LANDMARK AT LIGHTHOUSE COVE

MODIFICATION OF THE PLANNED RESIDENTIAL DEVELOPMENT

ZONING AMENDMENT APPLICATION FORM

LANDMARK at
 LIGHTHOUSE COVE
 OVERALL SITE PLAN

SHEET
 SP-01

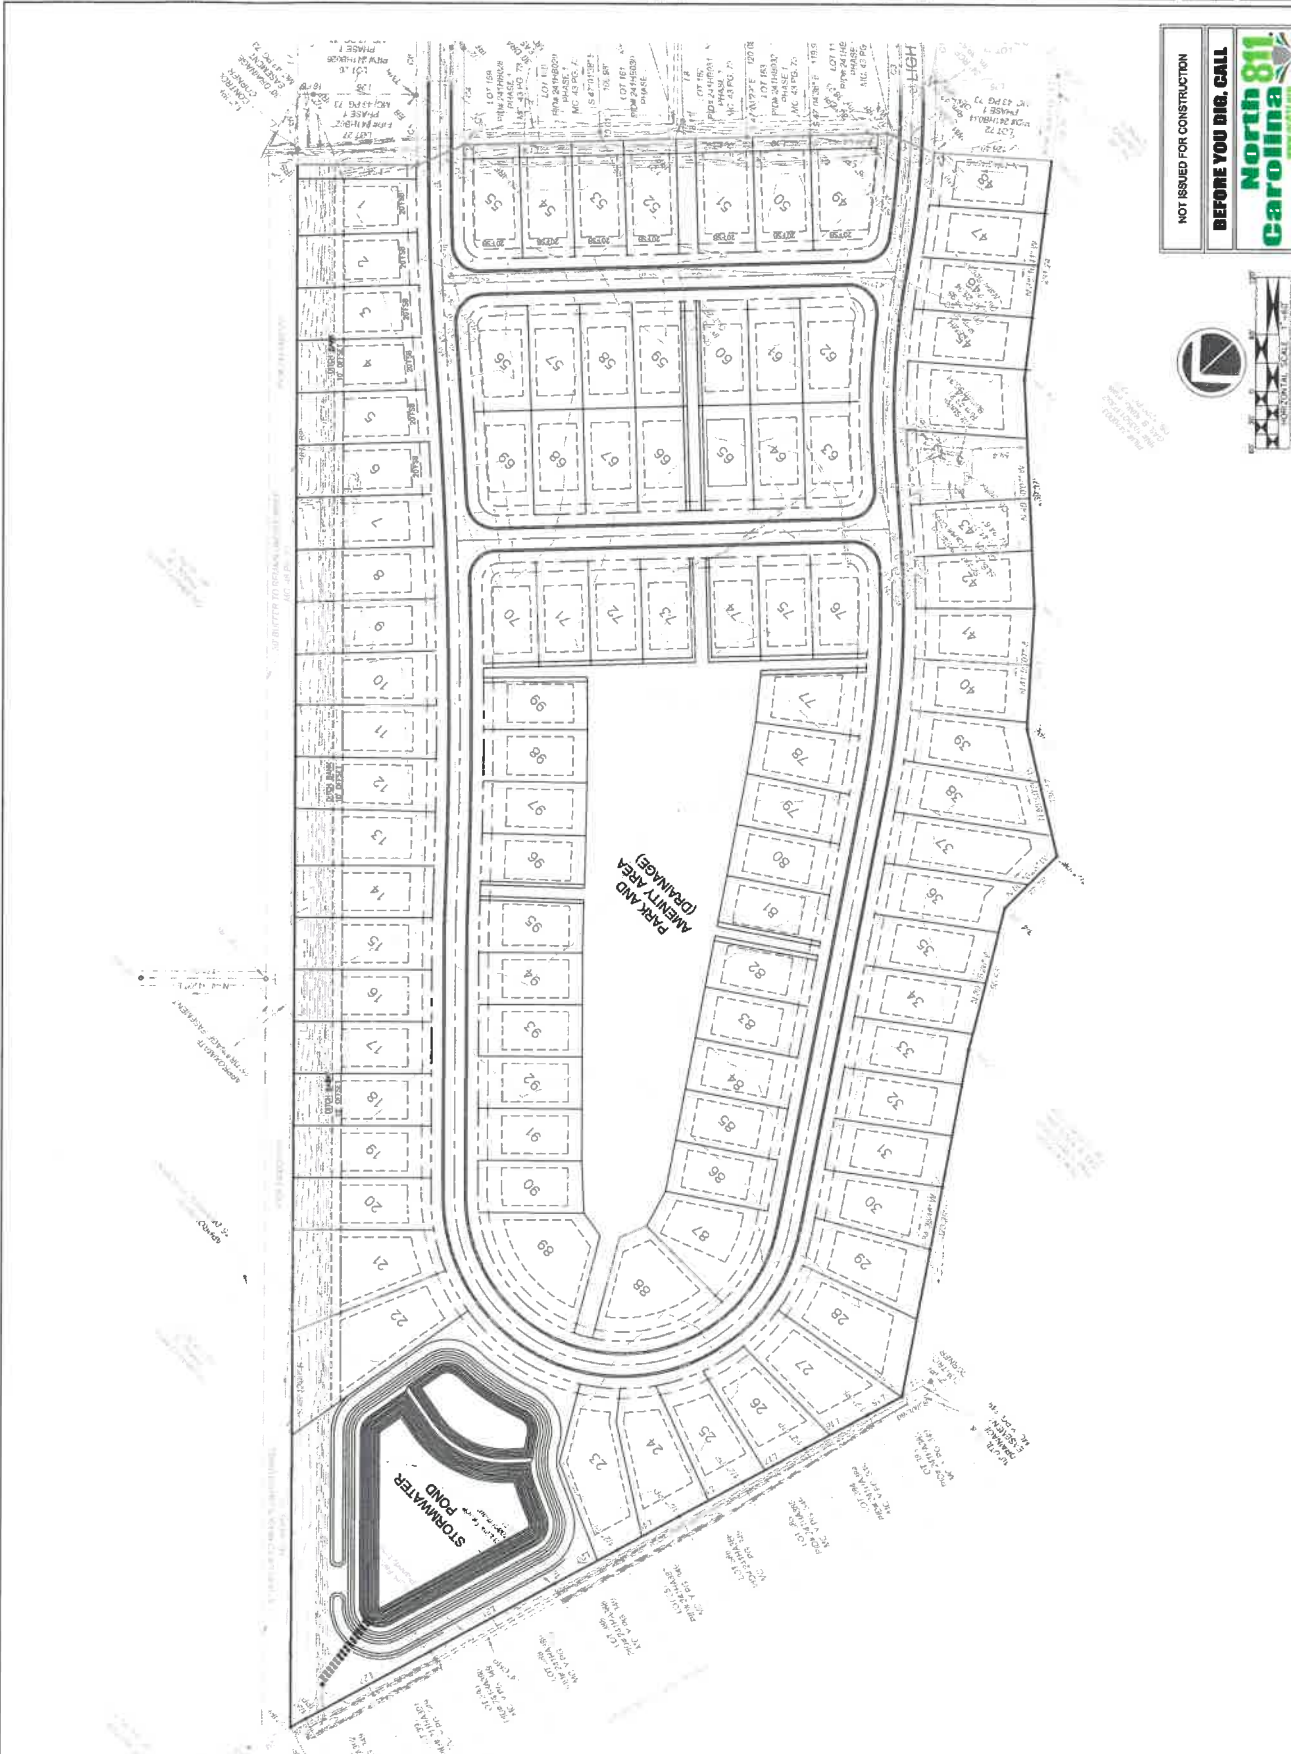
1. Drainage Ditch between Lighthouse Cove – Phase 1 and this property. The existing ditch straddles the rear property line of the Platted Lots within the Lighthouse Cove Subdivision and the proposed Lots (49-55) of Landmark. The top of bank and berm encroaches into the rear portion of the proposed Lots impacting the available buildable area. This area is further complicated by the necessary Street connections to the existing Streets and the location of the existing Sewer Main. Our request to allow a 5' reduction of the Front Yard Setback (25' to 20') for Lot 49-55 will resolve this issue.

2. Boundary Ditch Adjacent to Calabash Lakes
The existing ditch adjacent to Calabash Lakes is more internal to the property than anticipated. The Field Survey revealed a ditch cross-section with side slopes less than 1:1. Our evaluation of relocating the ditch, with required 2:1 side slope, resulted in impacting more internal property. The proposed Layout Modification includes a minor shift in the Street

alignment to maintain the desired building footprint and Setbacks. However, due to the necessary Street connections between the existing/proposed Lighthouse Cove Loop, proposed Lots 1-6 will be impacted. Our request to allow a 5' Front Yard Setback reduction (25' to 20') for Lots 1-6 will resolve the issue.

During the review process, a major concern was flooding and drainage. The original Subdivision Plan placed the Stormwater Pond in the center of the development with outfall connection to either, or both, of the boundary ditches. Our Engineering Analysis indicated a better hydrological option. The modified layout places the Stormwater Pond in the northern (lowest) corner of the property allowing positive drainage from the lots and streets. The center of the Site remains a 'Green Space' for an Amenity and Drainage. The revised Stormwater Pond location allows the Pond Outlet and Emergency Spillway to connect at the confluence of the boundary ditches. No site drainage is connected to the Village at Calabash drainage ditch.

The proposed modifications of the Landmark at Lighthouse Cove Subdivision remain true to the original intent with 3 fewer lots (102 to 99) and an improved engineered drainage and stormwater system. A 5' reduction of the Front Yard Setback is requested for Lots 1-6 and 49-55. There are no changes in the Side or Rear Setbacks.
